POWER PLANT - NACELLE - POWERPLANT - REPLACEMENT OF FASTENERS ON THE FCD LOCATOR -
CATEGORY CODE 7 - MOD.NAC-71-0171

V2500-NAC-71-0171

REPLACEMENT OF DOOR LOCATOR FASTENERS
FIG.1

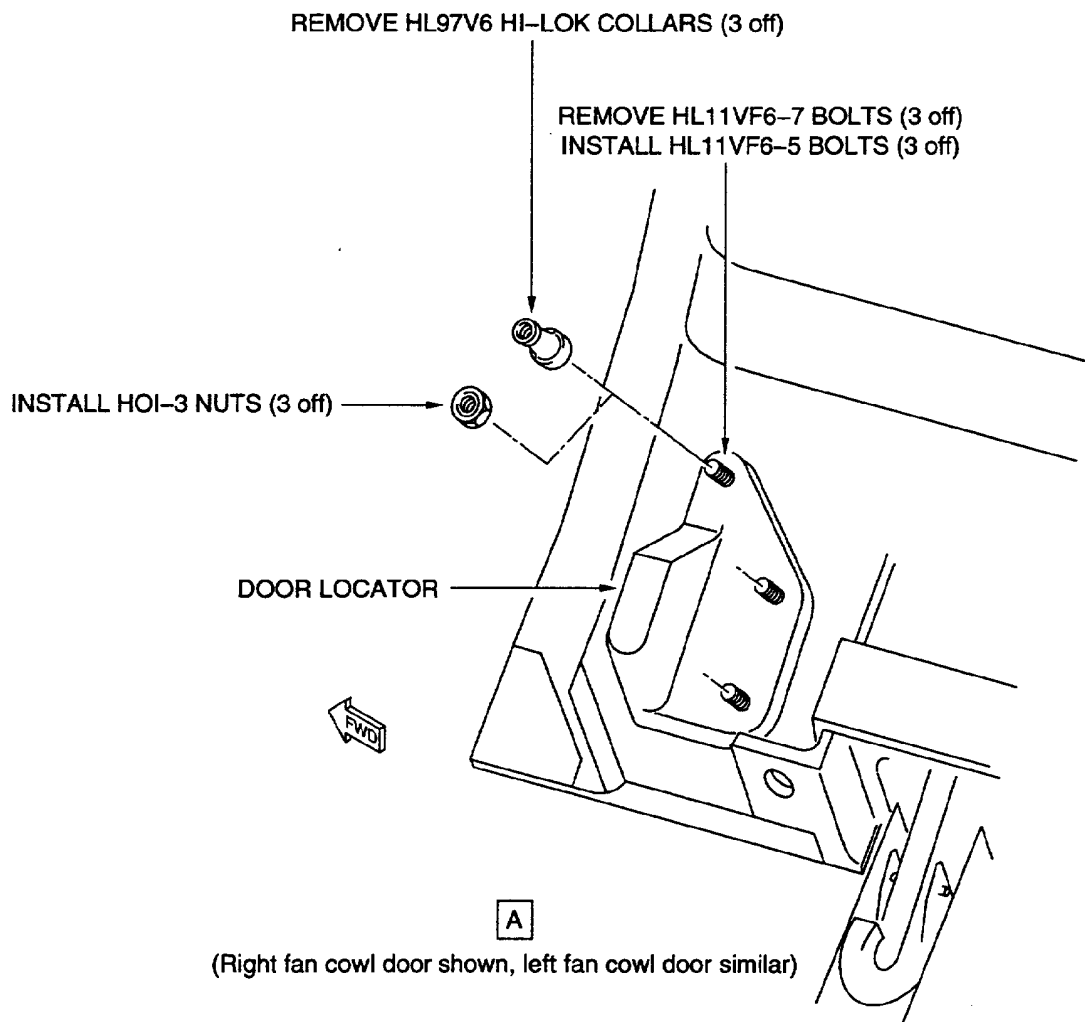
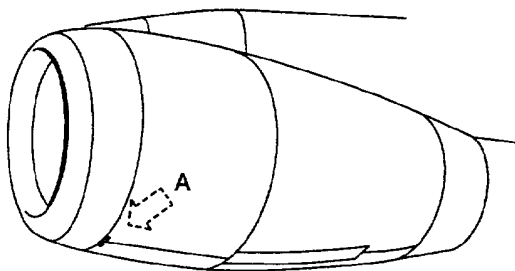
When the fan cowl doors are in the closed position the fasteners that secure the right and left FCD locators to the doors may contact the nose cowl guide bar.

- (a) The existing bolts and collars that attach the locators to the left and right FCDs are removed and replaced with shorter bolts and self locking nuts.

- (1) Remove an HL97V6 Hi-lok collar and an HL11VF6-7 Hi-lok bolt from the left fan cowl door. (Refer to Figure 1).
- (2) Install an HL11VF6-5 bolt and an H01-3 Kaynar nut to the left Fan Cowl Door in place of the bolt and nut removed in step B.(1).
- (3) Replace the two remaining Hi-Lok bolts and collars on the left Fan Cowl Door as instructed in steps B.(1) and B.(2).
- (4) Torque the Kaynar Nuts to 40lb in (4.52 Nm).
- (5) Restore the paint finish to the left Fan Cowl Door.
- (6) Do steps B. (1) thru B.(5) for the right Fan Cowl Door.
